AUSTRALIAN MOTOR VEHICLE CERTIFICATION BOARD
179th MEETING: 26 November 1997

**MINUTES
179th MEETING
Wednesday 26th November 1997
SYDNEY NSW**

THREE WHEEL VEHICLE

Prototype Three Wheel Vehicle

THE VEHICLE

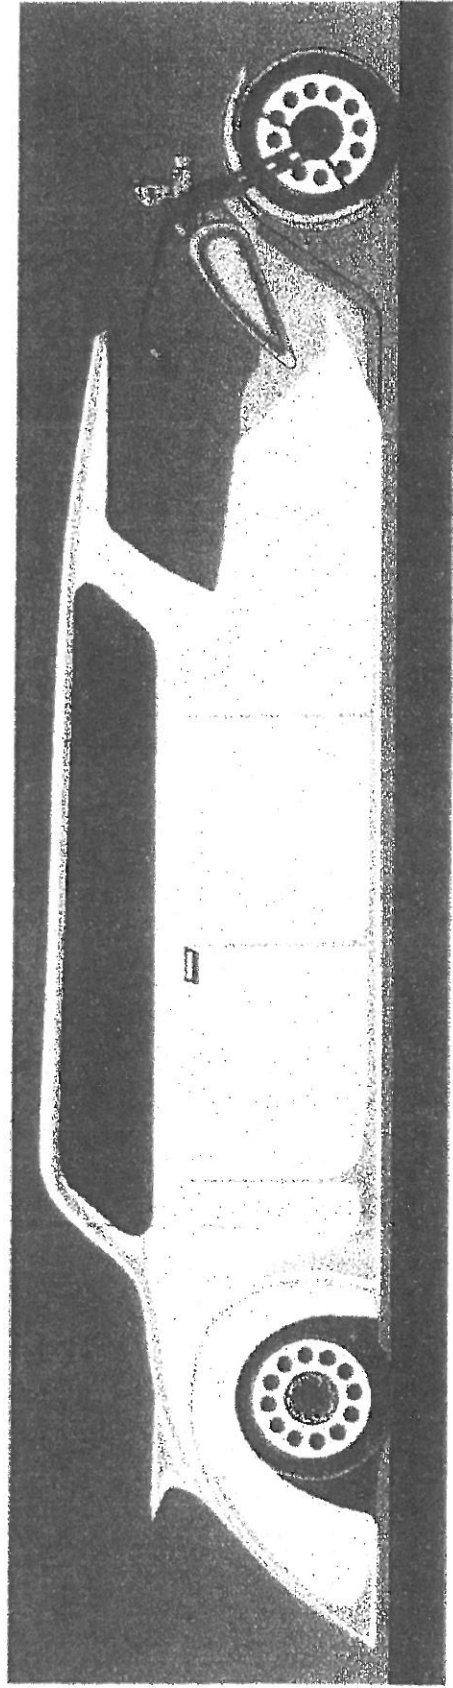
FORS view is that use of such a vehicle be allowed only subject to it meeting all the ADRs applicable. Considering it would not be possible for the suggested design to meet ADR 69, the vehicle can be certified only under Motor Tricycle category. It needs to be made clear to the developer that vehicle 'Gross Vehicle Mass' should be less than 1 tonne to be able to be eligible under Motor Tricycle category.

As indicated, on the enclosed photographs and drawings, the vehicle is basically a three wheeled "limousine". It has a V6 car motor mounted in East/West configuration located at the rear of the vehicle. The front wheel and forks are from a Harley Davidson motorcycle. The vehicle will be driven and steered from this front end with the driver seated on a car type seat and controlling the motorcycle front fork assembly via handlebars. The vehicle body consists of a fibreglass shell mounted onto an RHS steel framework/chassis.

At this stage the gross vehicle mass is not known. However, we estimate that it may exceed the 1 tonne limit. If this is the case, then from our interpretation of the ADR's, the vehicle would have to be classified as either a Passenger Car (MA) or as a Forward Control Passenger Vehicle (MB). The MB classification would be dependent on how the Board defined the "Steering Wheel" for this particular vehicle.

A major problem arises with these latter classifications in meeting the intent of ADR 69 "Occupant Protection". With the motorcycle type front end it would not be possible to pass a crash barrier test.

Agreed if vehicle is below one tonnes GVM must meet LEP category requirements; if over one tonne GVM then must meet MA category requirements.
